**FINAL DRAINAGE REPORT
FOR
ABTR STORAGE
UNPLATTED
415 N FRANCEVILLE COAL MINE ROAD
COLORADO SPRINGS, COLORADO**

MARCH 2023

Prepared By:
TERRA NOVA ENGINEERING, INC.
721 S. 23RD Street
Colorado Springs, CO 80904
719.635.6422

PPR2319

ABTR STORAGE SITE DEVELOPMENT PLAN PROPOSED DRAINAGE MAP MARCH 2023

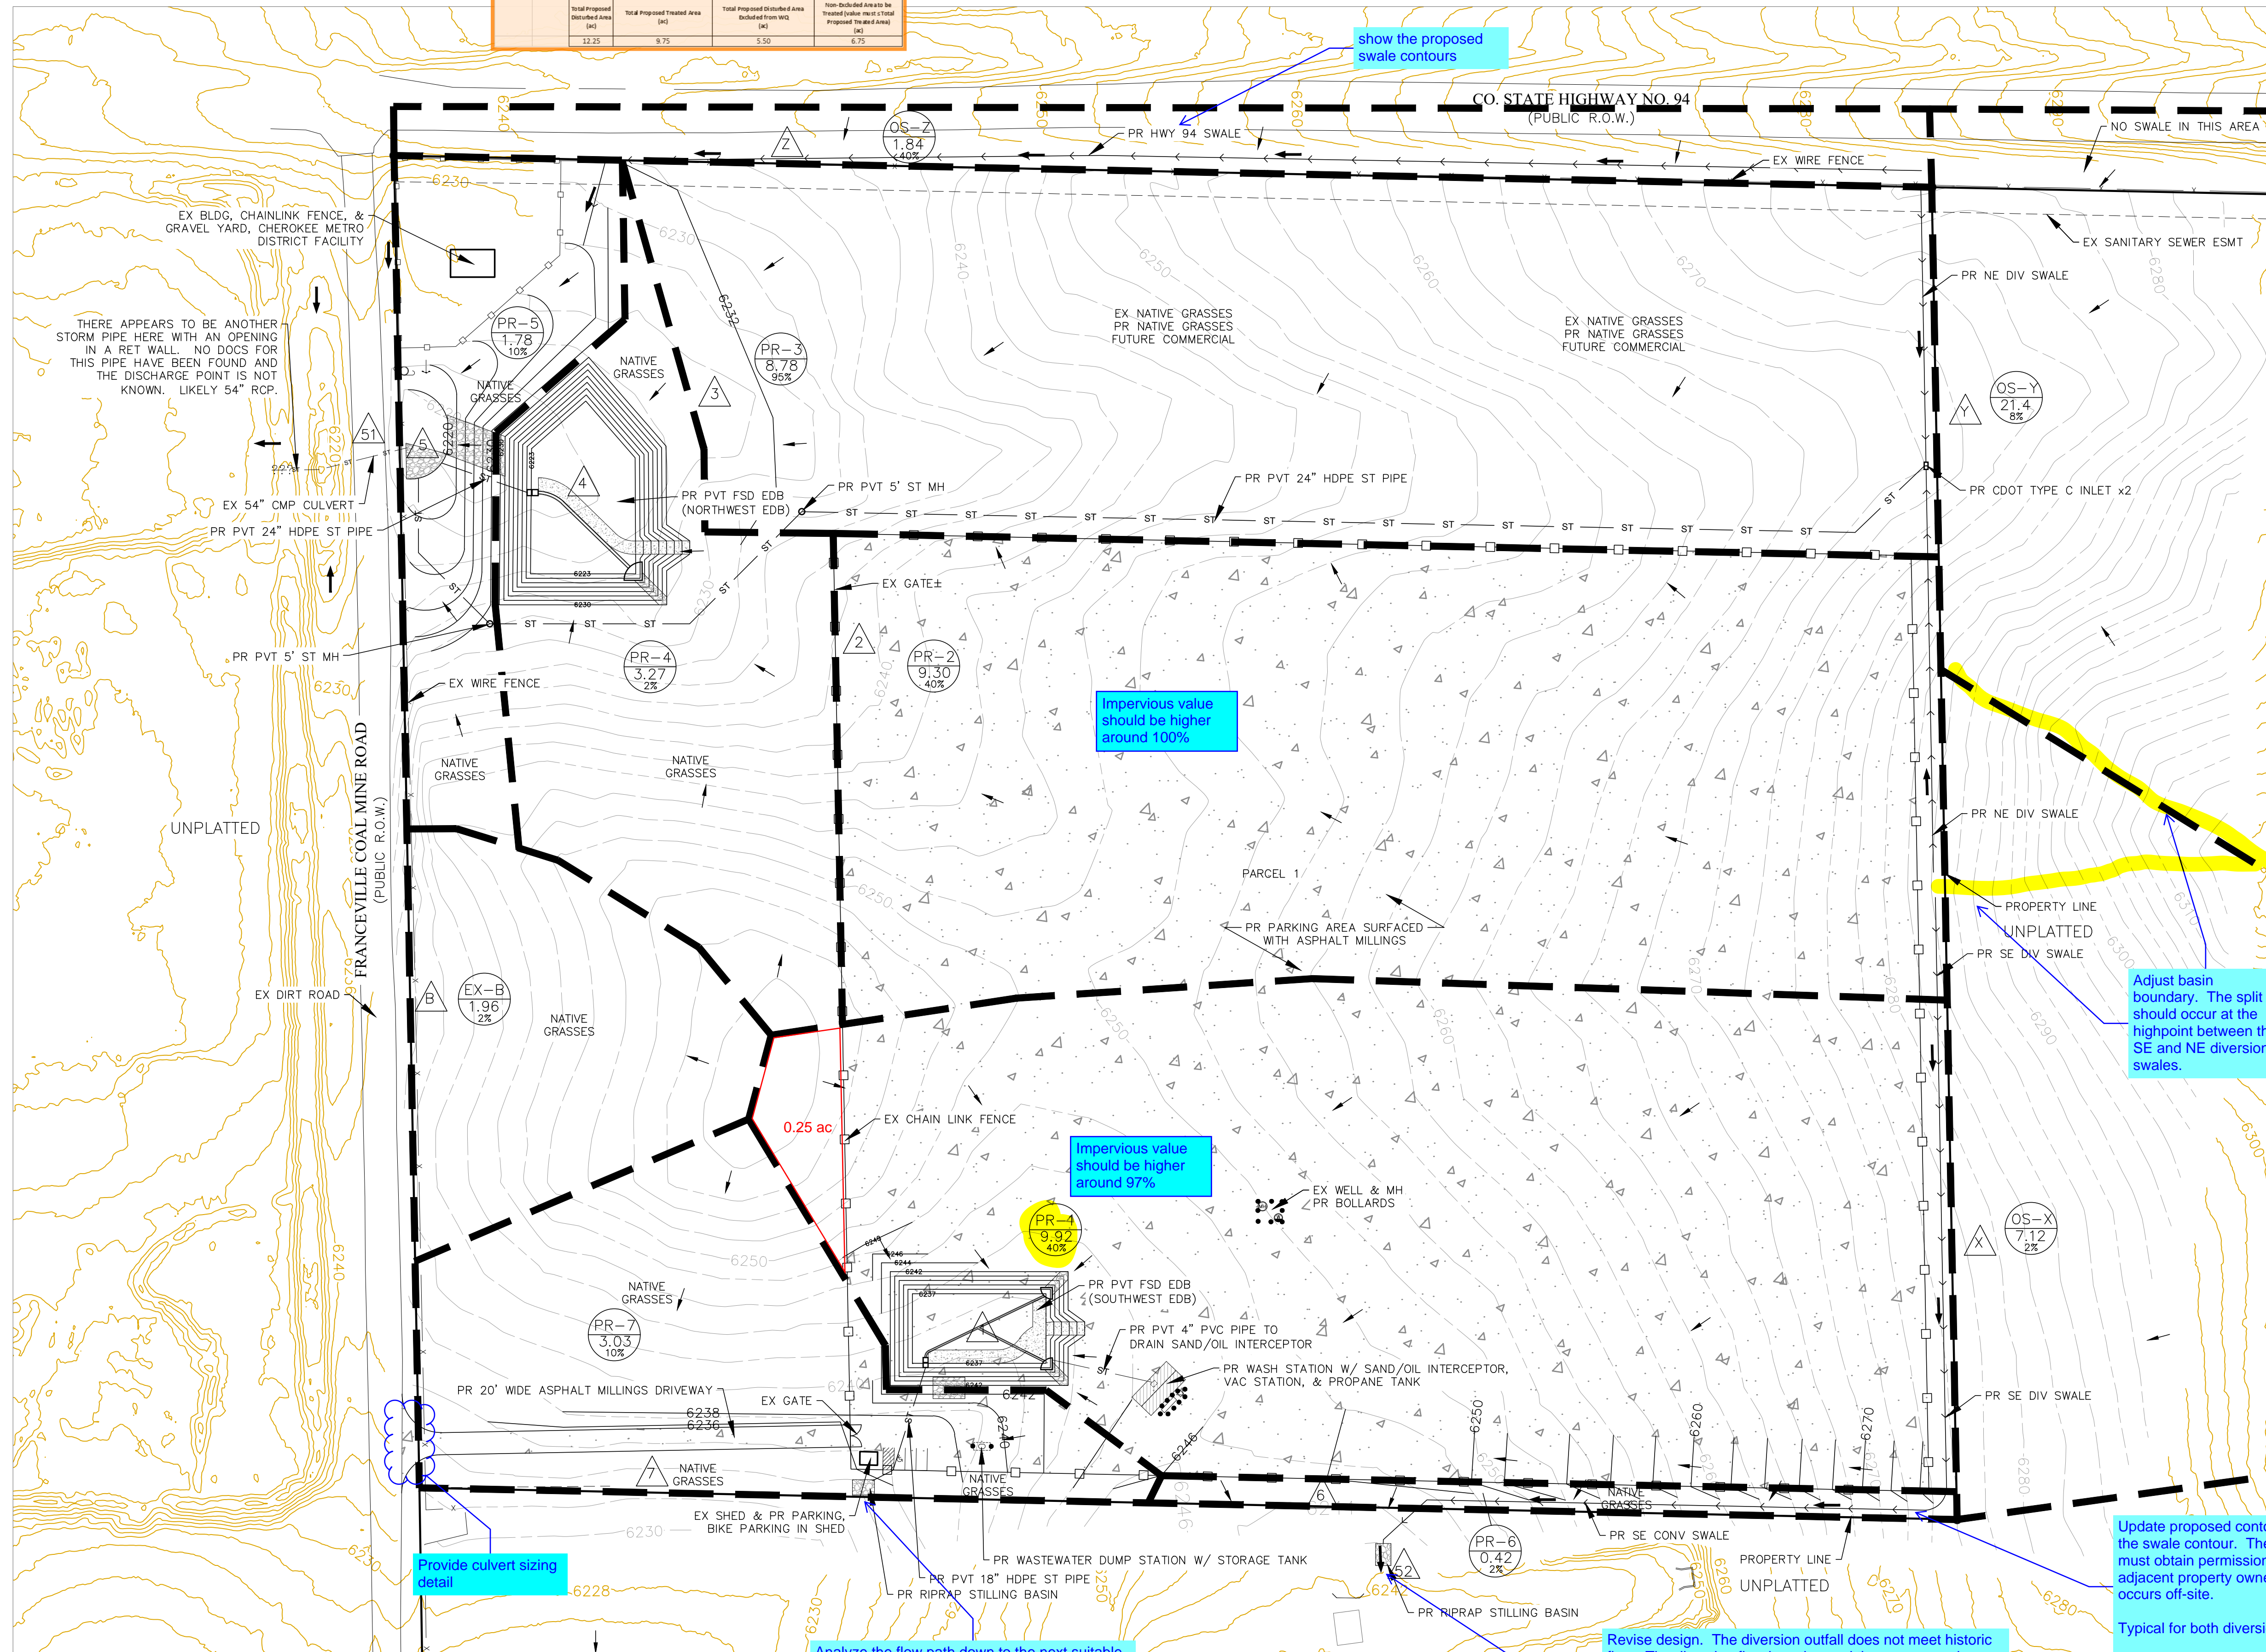
Revise design. The diversion outfall does not meet historic flow. The diversion flow has changed the manner and quantity of flow. Historically, runoff was sheet flow as it enters the adjacent property. The current design has changed this to a concentrated flow.

Update proposed contour to show the swale contour. The applicant must obtain permission from the adjacent property owner if grading occurs off-site.

show the proposed swale contours

Revise pond release rate so flows at DP 5 is equal to or less than existing condition DP C

SWALE CROSS SECTION - SE DIV

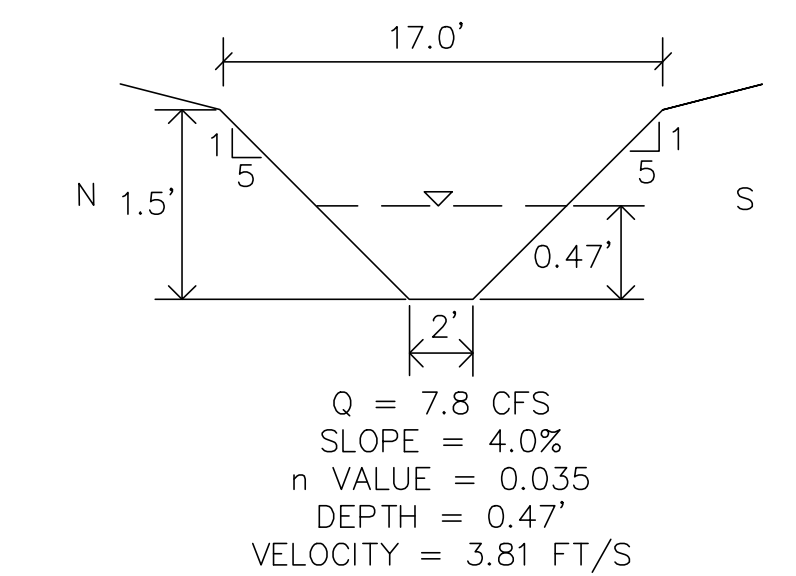
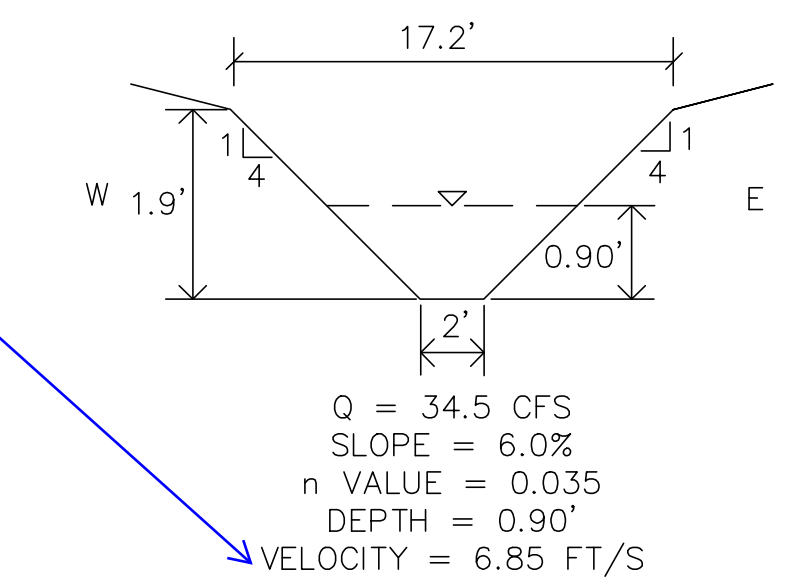
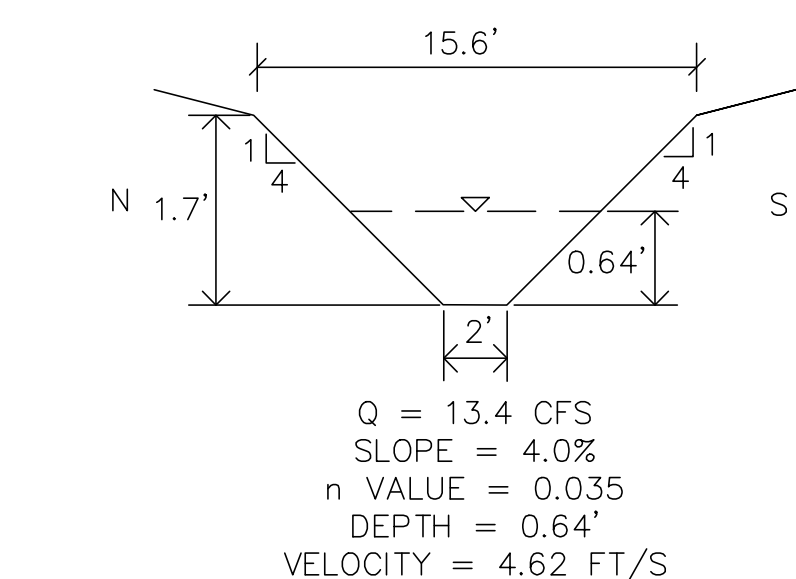
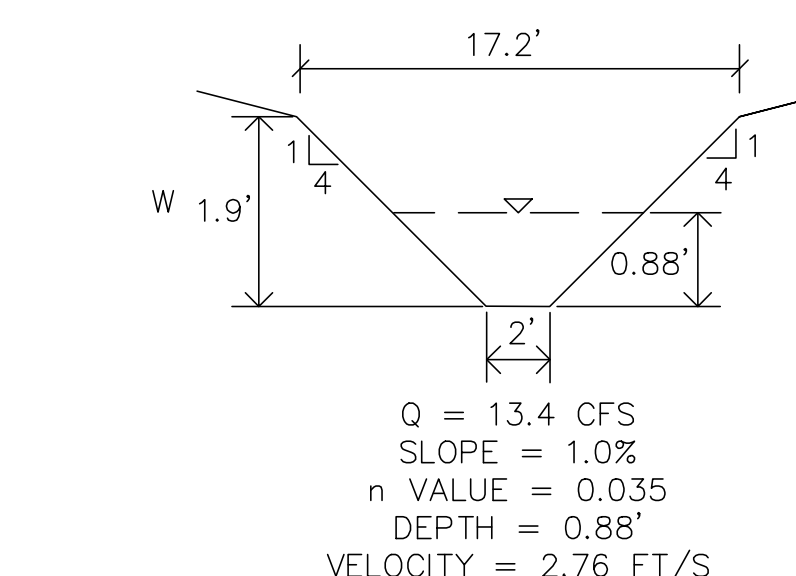
Provide recommendation for armoring on ditch since velocities are erosive per criteria.
